## **Amendments to CEVNI based on article 6.32 and chapter III “Marks on the banks indicating the position of the fairway” of annex 8 of the Basic Rules of Navigation on the Danube**

This document contains amendment proposals to CEVNI 5: (a) article 6.32 to CEVNI, paragraphs 2 and 3, and (b) annex 8, part III, based on the respective provisions of DFND (see ECE/TRANS/SC.3/WP.3/2021/4).

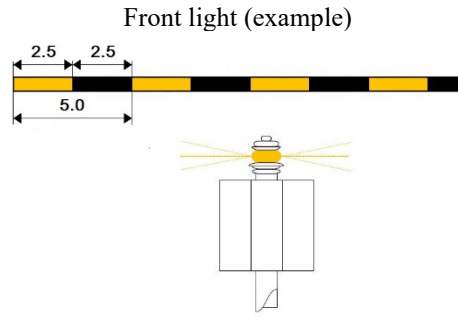
The CEVNI Expert Group may wish to replace “marks on land” with “bank marks” in the text of part III in accordance with SIGNI and to add a reference to chapter 6 of SIGNI “Installation of signs and marking in characteristic sections of the river”.

Fig.11 bis

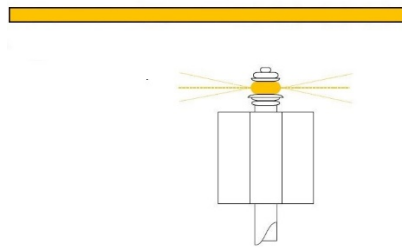
#### **C. Marker posts**

##### **1. Right bank**

Two boards (front and back boards) with lights (example – figure 8, sketch 4.C).

Light: yellow  
Front light: isophase  
Back light: fixed.

Fig.11 ter

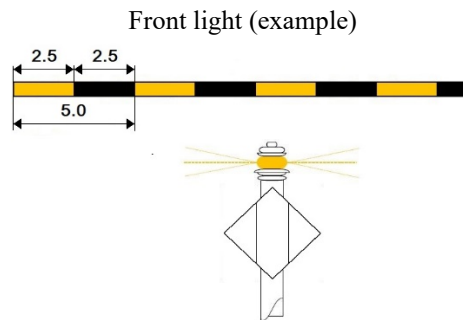
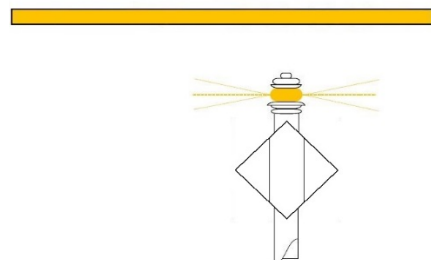
## 2. Left bank

Two yellow boards (front and back boards) with lights (example – figure 9, sketch 5.C).

Light: yellow  
Front light: isophase  
Back light: fixed.
